SHIP PC	MARK	ASSM PC	DESCRIPTION	LENGTH MM	SPEC	ID
2	21-A	4	TERMINATION SUPPORT RING ASSEMBLY			
	21-1		PL SK X 25 (1")		M8	Ac
4	21-2		PL SK X 25 (1")		M8	C
2	21-3 R/L		PL SK X 25 (1")		M8	C
2	21-4 R/L		PL SK X 25 (1")		M8	C
			M8 = SEE SPEC C-TERMSTF (SA240-TP304L)

DETAILED AND BILLED FOR (1), (16) REQUIRED

CUSTOMER'S NO		CONTRACT NO	
BY DTR_CHKD CST DATE 4/16/96		953571	
M. L. TELLALIAN		DWG	REV
ENGINEERING ASSIGNED		21	2
SHT

2190-D960513-02-B

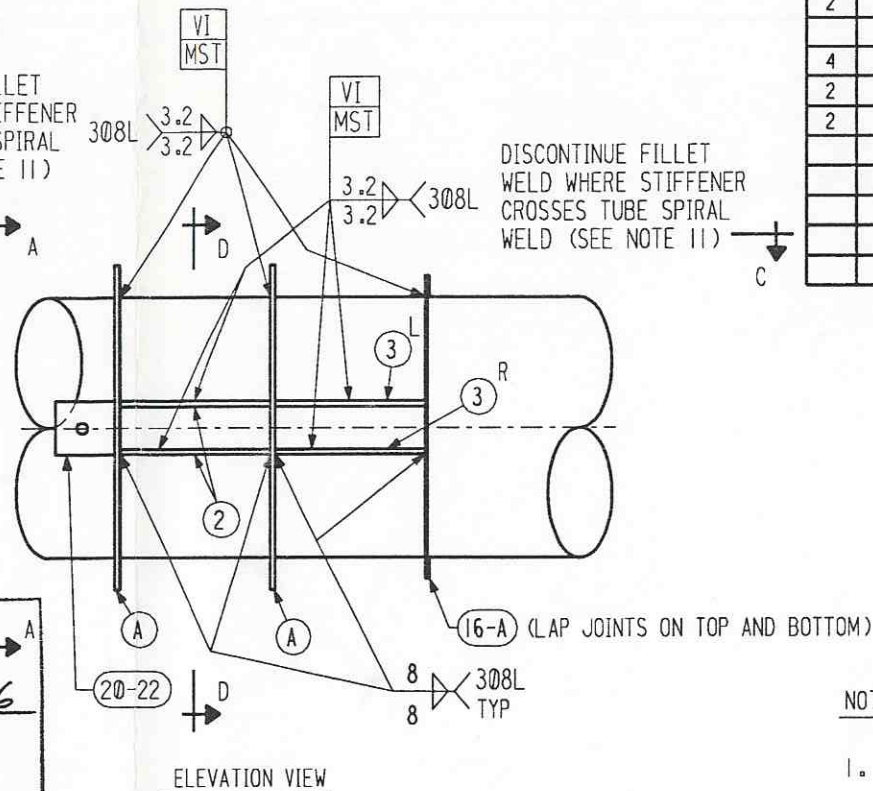
DISCONTINUE FILLET WELD WHERE STIFFENER CROSSES TUBE SPIRAL WELD (SEE NOTE 11)
